**SECTION 00 90 01
BIDDING AND CONTRACT REQUIREMENTS
ADDENDUM NUMBER (5)**

Issued: April 30th, 2024

Re: ADDENDUM NUMBER (5) TO THE BIDDING DOCUMENTS FOR

**Peoria Park District
Golf Entertainment Facility Renovation an Addition
Architect's Project Number: 22-051**

1 FIRST FLOOR FINISH PLAN
1/8" = 1'-0"

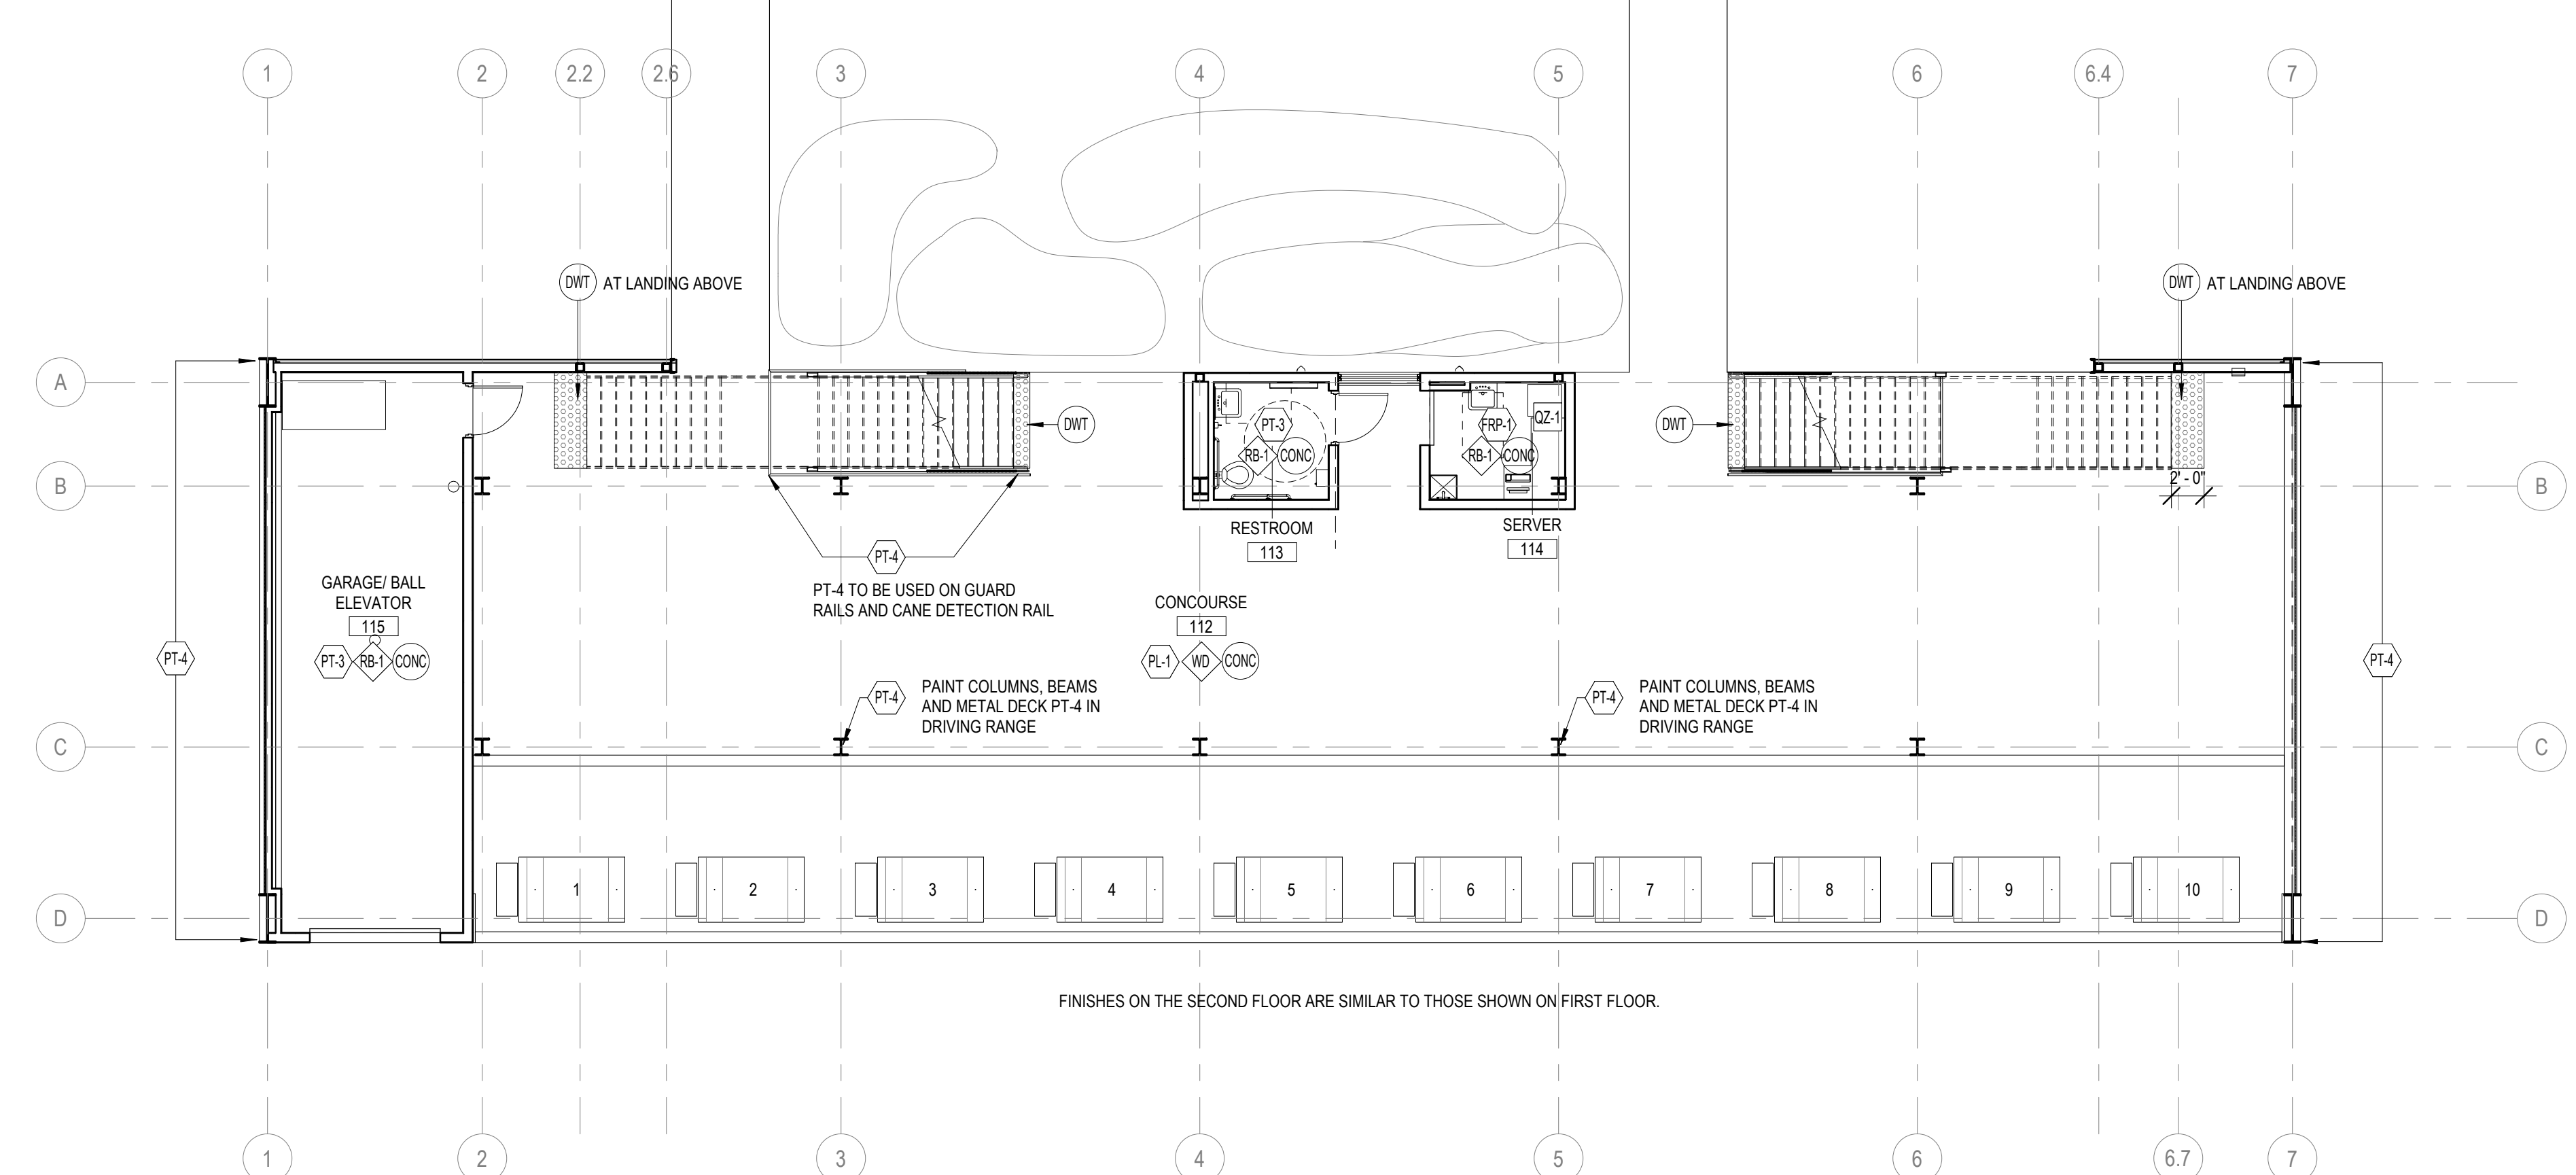
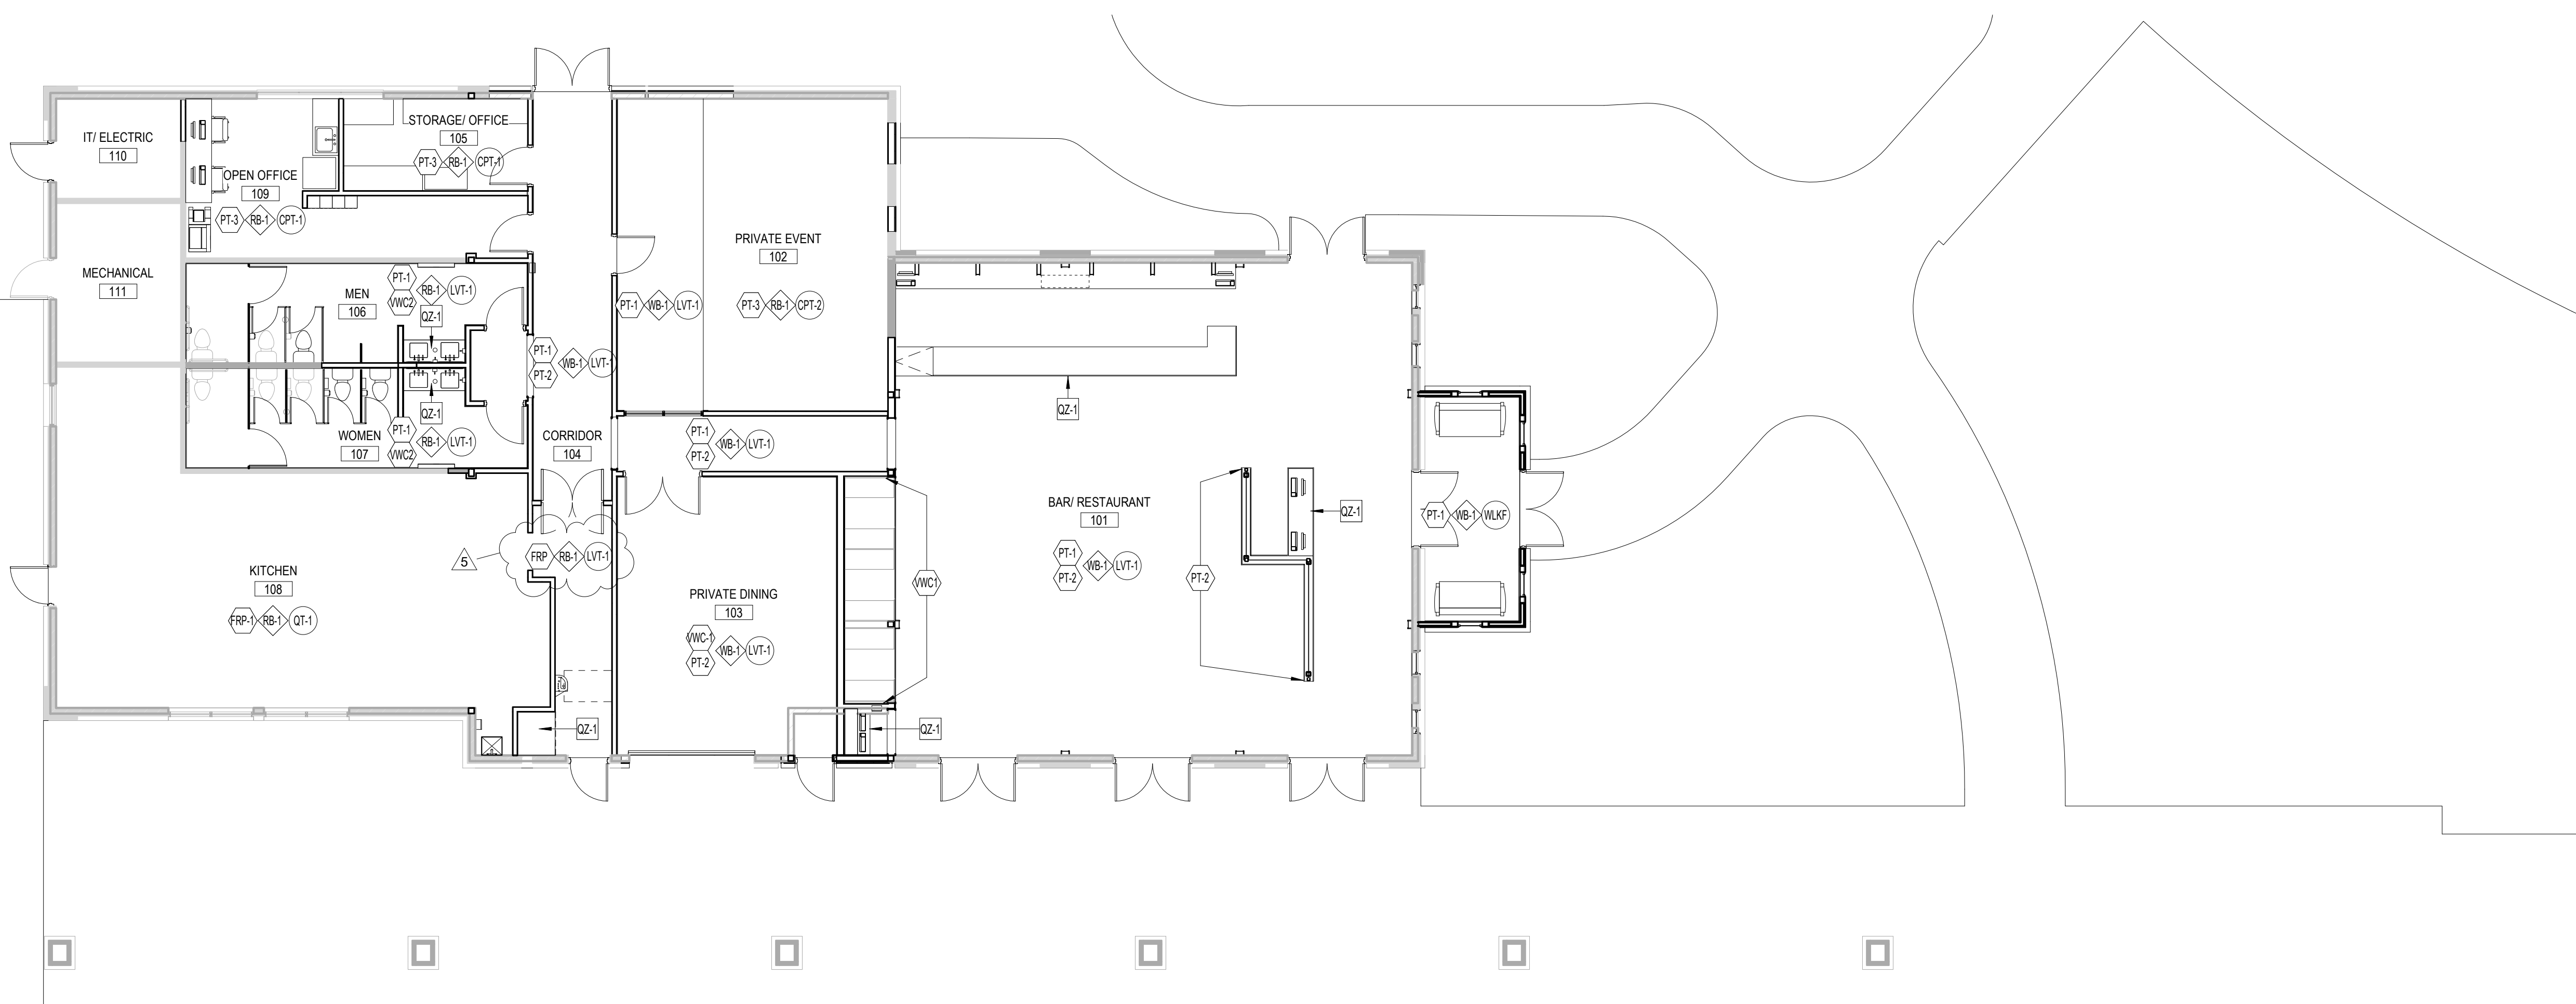
2. There is what appears to be a corridor between Corridor 104 and Kitchen 108 without a material listed. Does this area get new flooring, and if so is it meant to be LVT-1 like Corridor 104 or QT-1 like Kitchen 108?

LVT-1 Flooring, Rubber base, FRP on the walls. – see revised finish plan (will have on the addendum)

SHEET TITLE:
FIRST FLOOR PLAN - CLUBHOUSE - PLUMBING

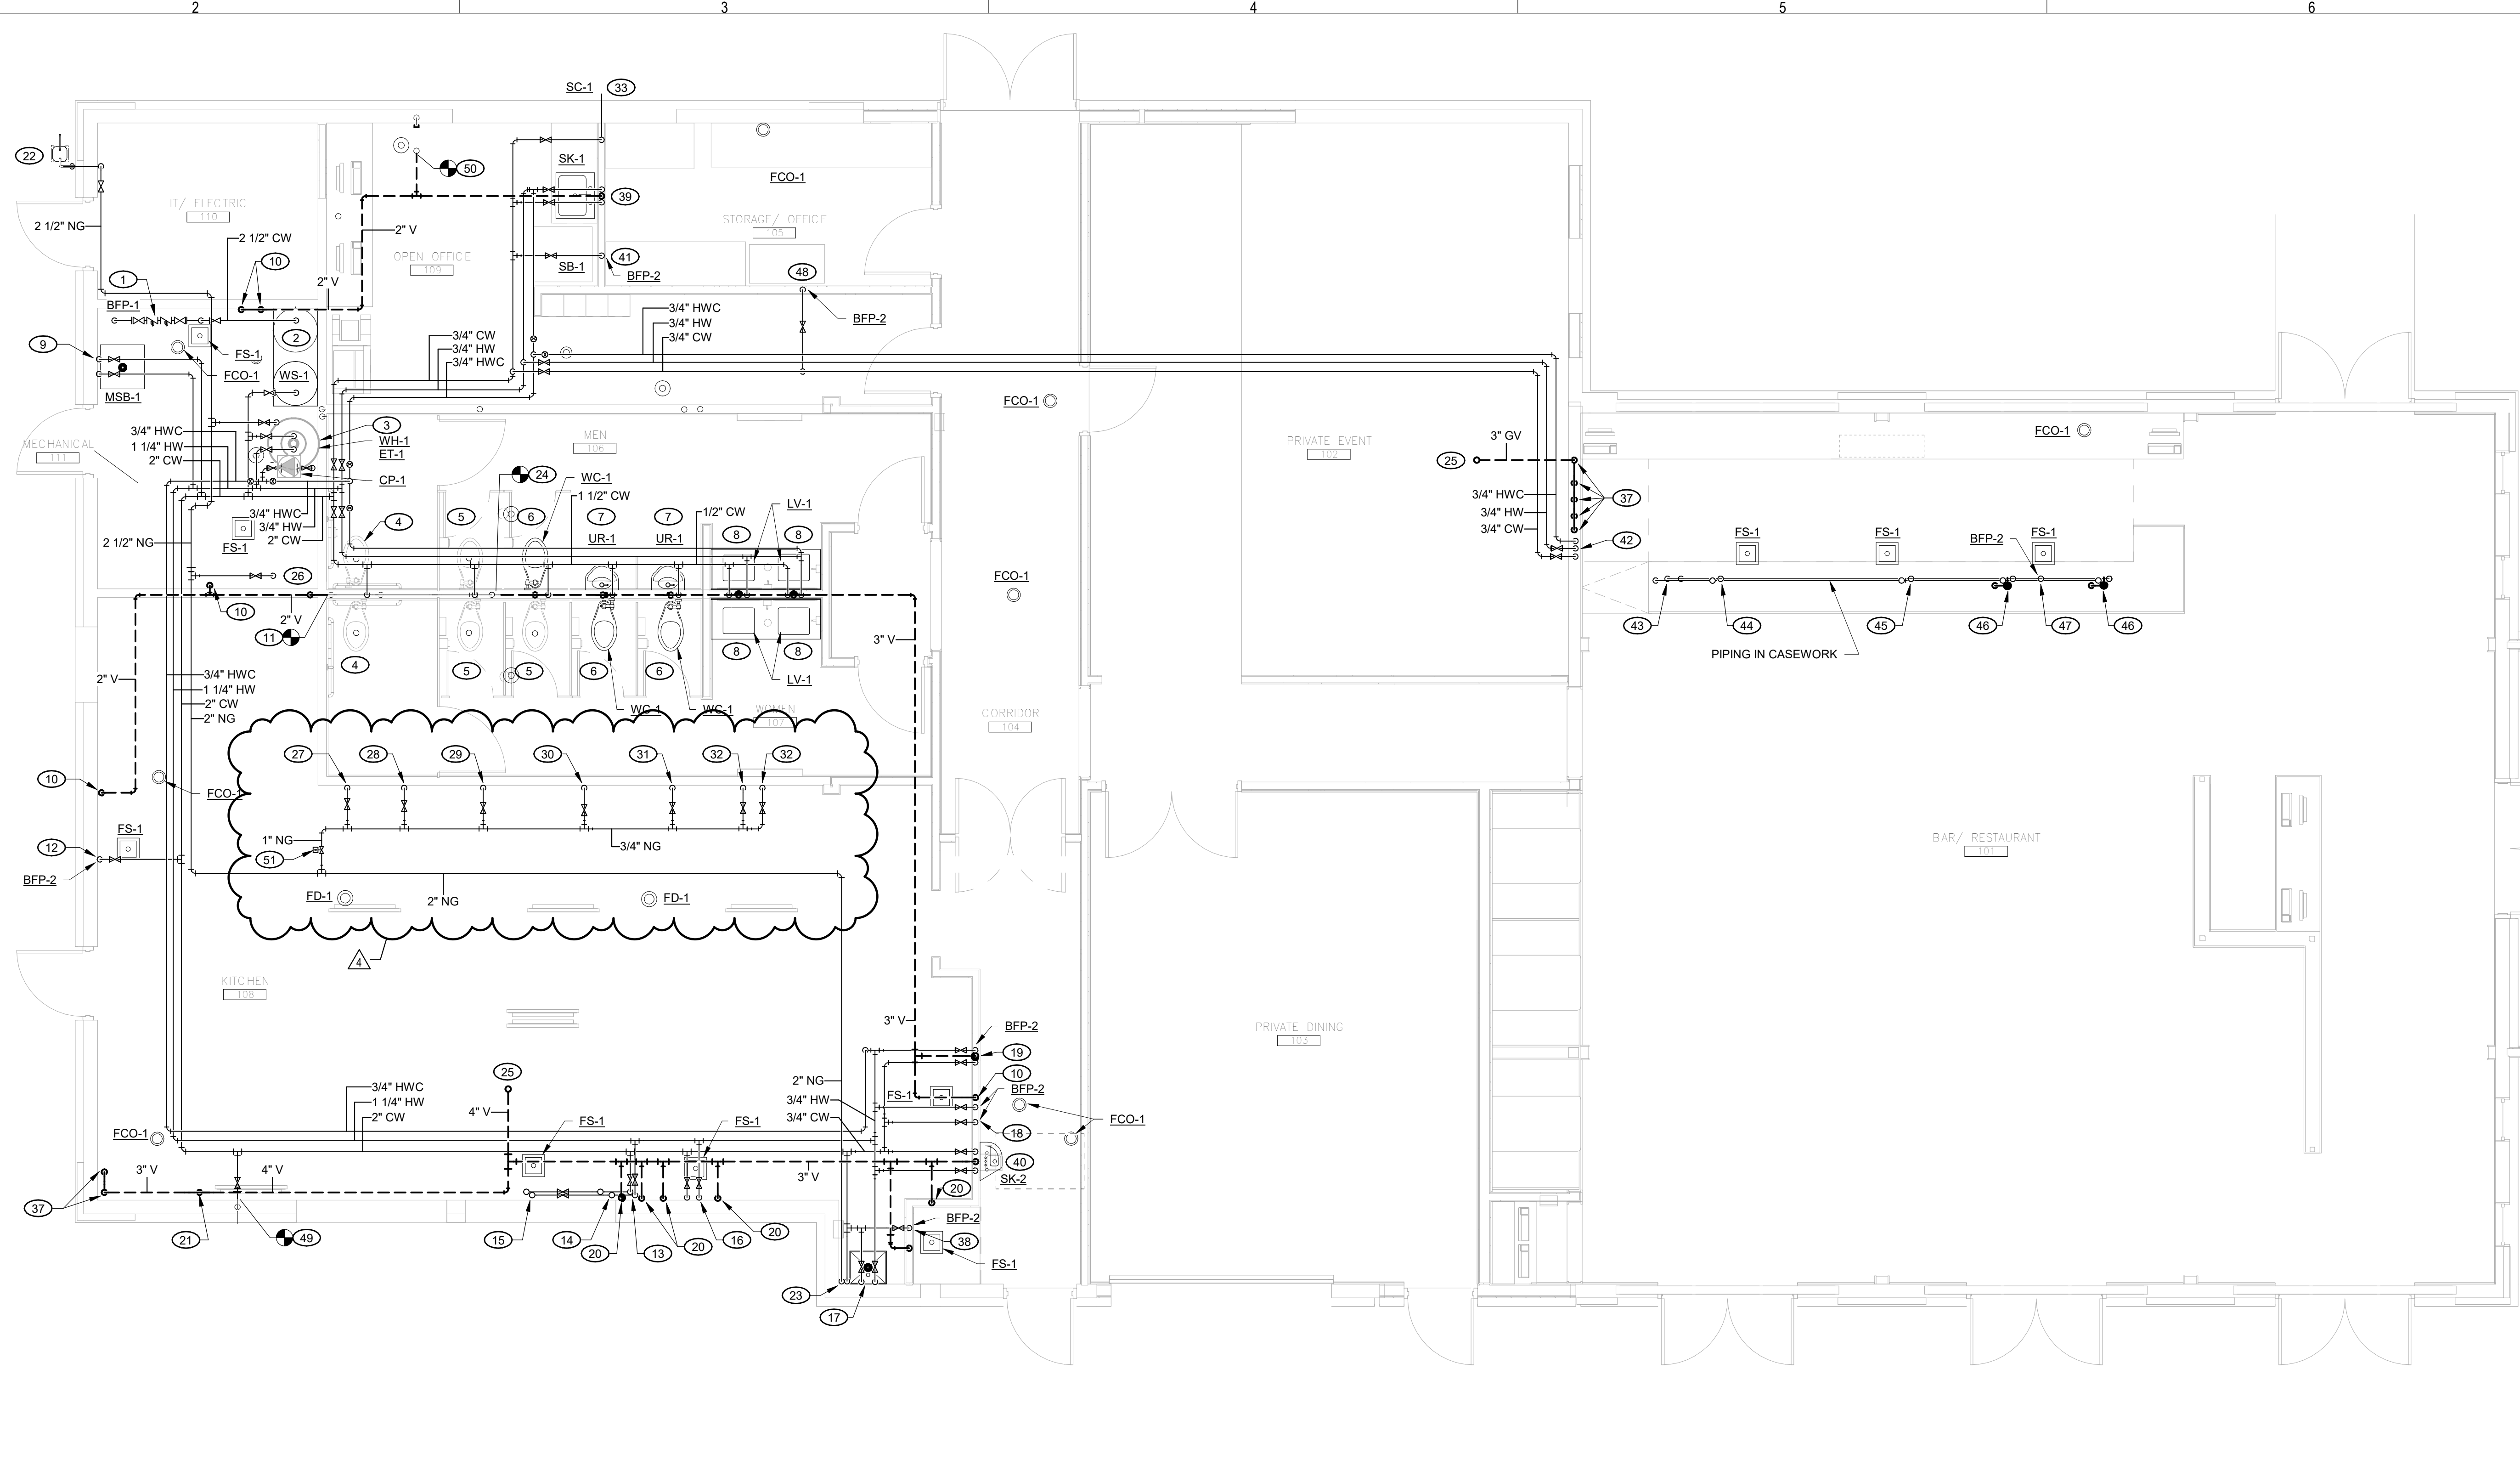
1. Drawing P1.01 – First Floor Plan – Clubhouse – Plumbing
 - a. Reworked gas piping to have all the kitchen equipment beneath the hood on their own branch.
 - b. Added a 120V normally closed solenoid valve to the branch piping for gas fired kitchen equipment below the hood.

- a. Reworked gas piping to have all the kitchen equipment beneath the hood on their own branch.
 - b. Added a 120V normally closed solenoid valve to the branch piping for gas fired kitchen equipment below the hood.

- 51 PROVIDE AND INSTALL A 1" 120V NORMALLY CLOSED SOLENOID VALVE FOR GAS EQUIPMENT BENEATH HOOD. POWER WIRING BY ELECTRICAL CONTRACTOR.
